RENESAS TECHNICAL UPDATE

Product Category	MPU&MCU		Document No.	TN-SH7-A622A/E	Rev.	1.00
Title	Underflow will occur when SSI is disabled during slave transmission		Information Category	Technical notification		
Applicable Product	R5S77640P300BG R5S77640D300BG R5S77640N300BG R5S77641P300BG R5S77641D300BG R5S77641N300BG	Lot No.	Reference Document	SH7764 Hardware Manual (REJ09B0360-0100)		
		All lots

Figure 18.19 Transmission Using SSI_DMAC0 and SSI_DMAC1 (Corrected programming flowchart)

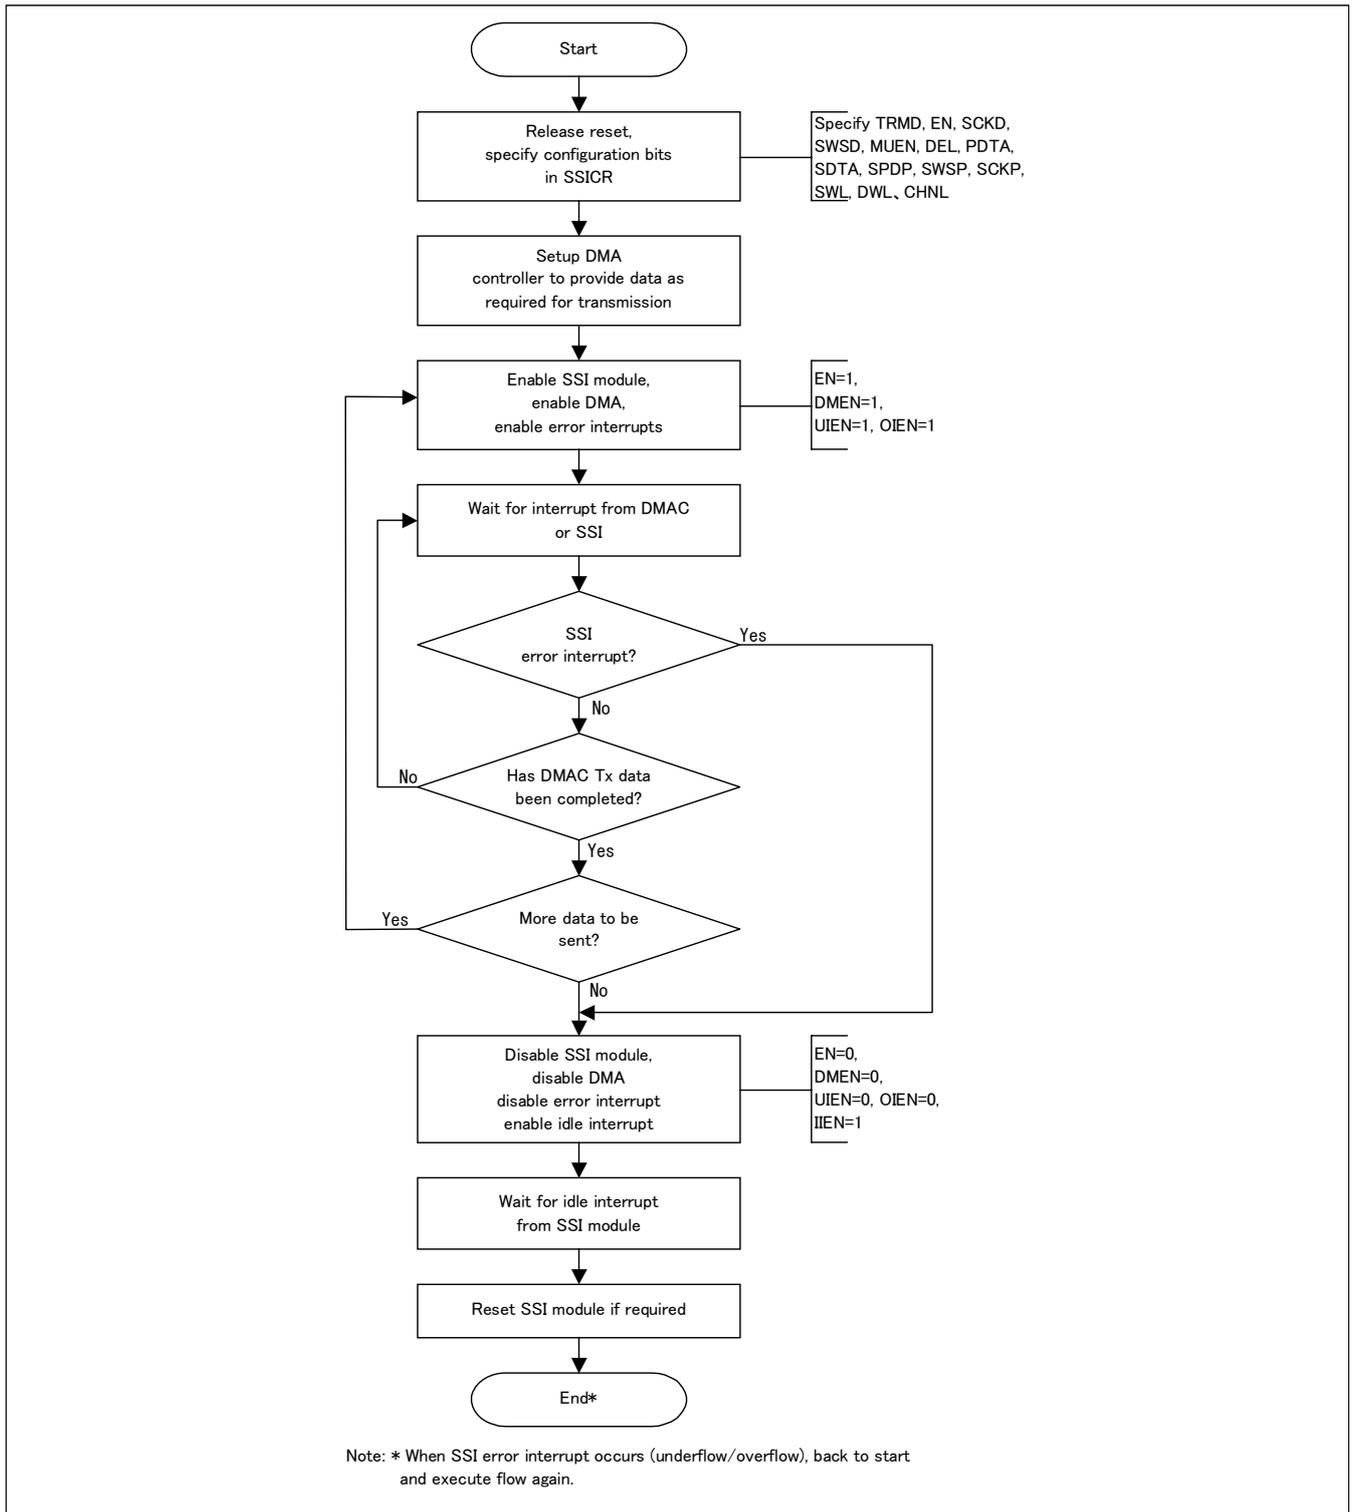
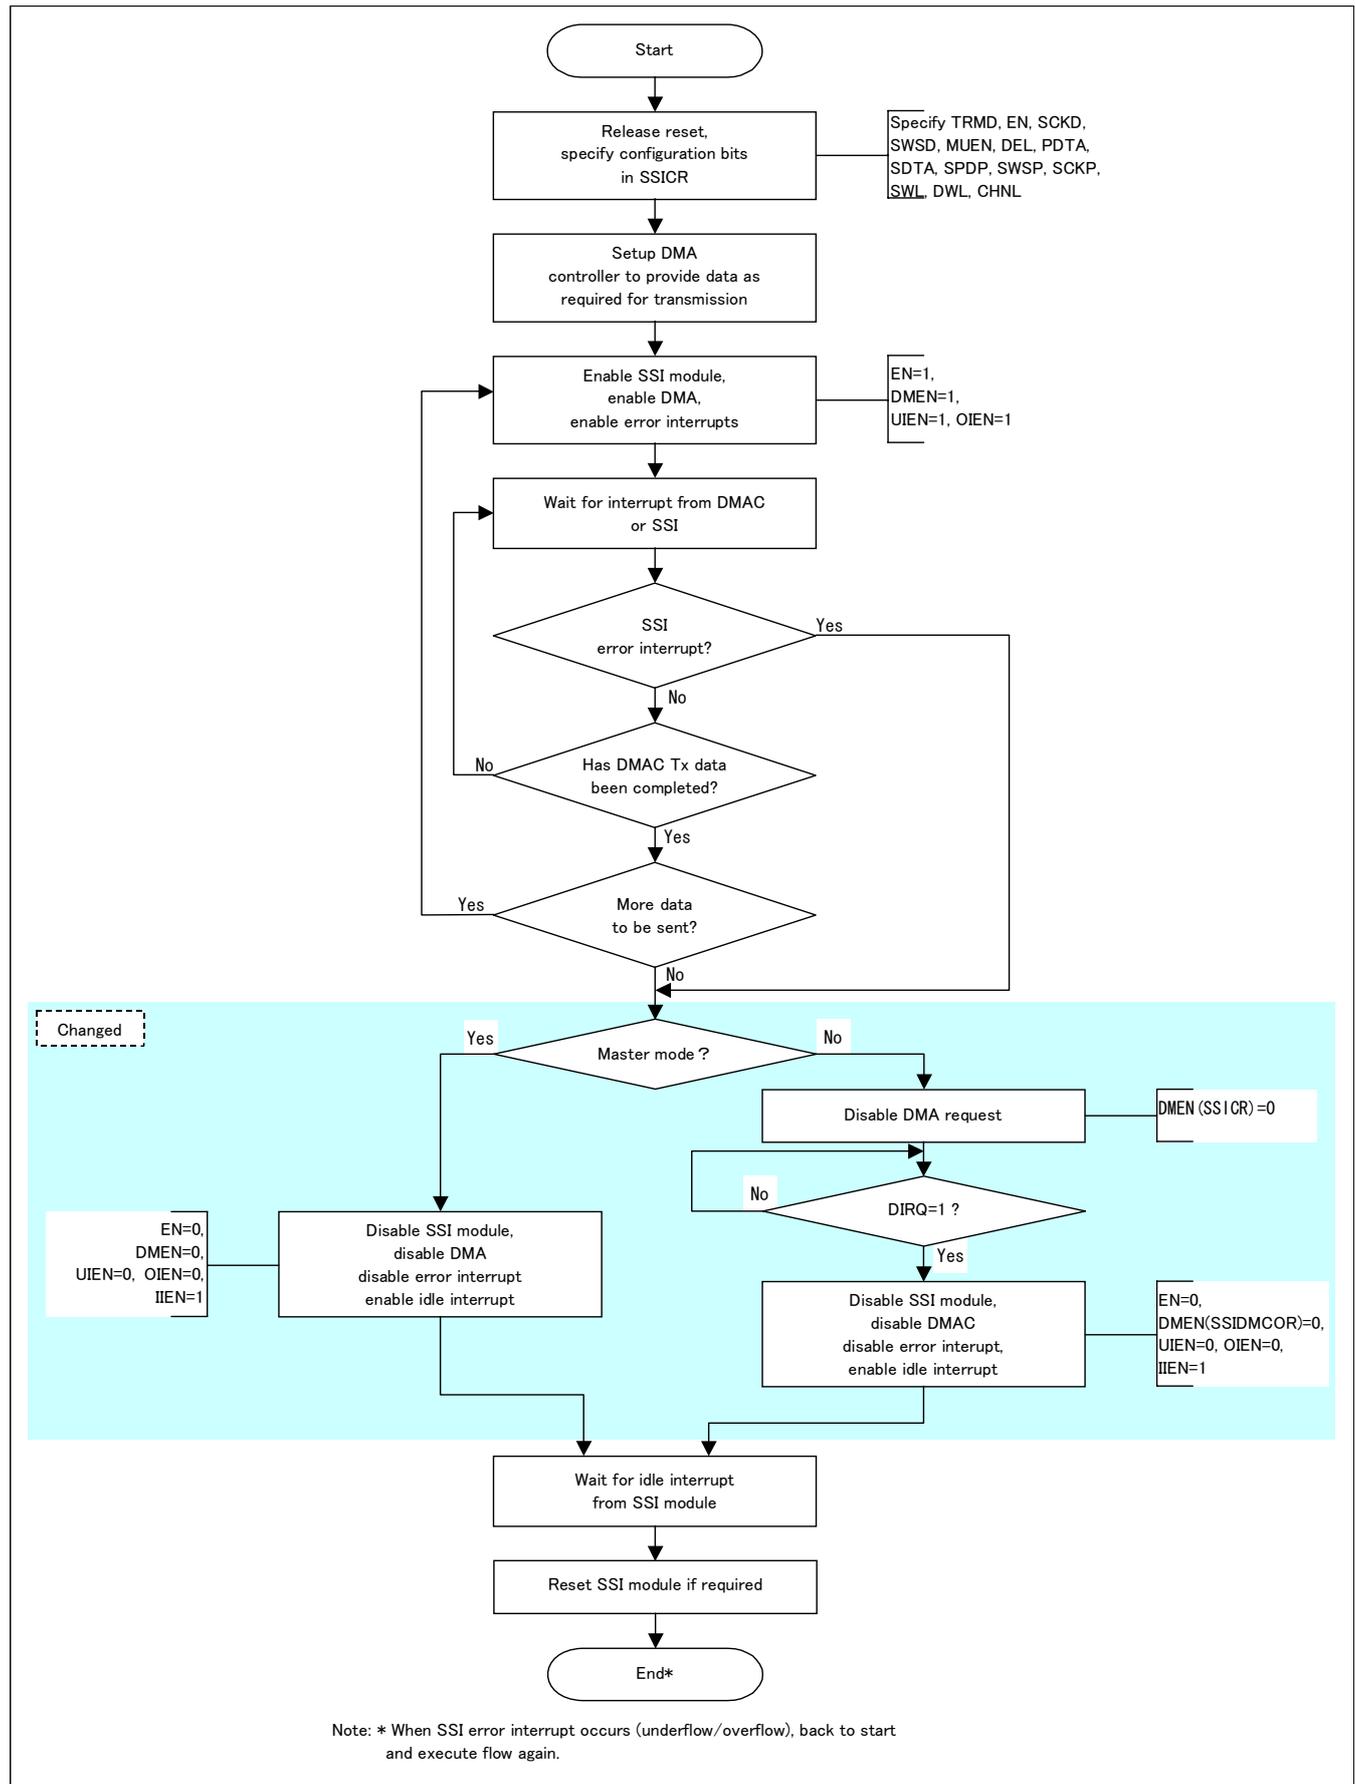
When SSI is disabled by clearing SSICR:EN bit during slave transmission using SSI_DMAC, underflow will occur in next slave transmission.

In order to prevent this problem, figure 18.19 "Transmission Using SSI_DMAC0 and SSI_DMAC1" (Page 692) in the hardware manual is corrected. Please refer to next two pages.

To stop ongoing slave transmission using SSI_DMAC, disable DMA request first by clearing SSICR:DMEN bit and wait until transmission buffer gets empty (SSISR:DIRQ=1), then disable SSI by clearing SSICR:EN bit and wait until idle mode status flag becomes 1 (SSISR:IDST=1).
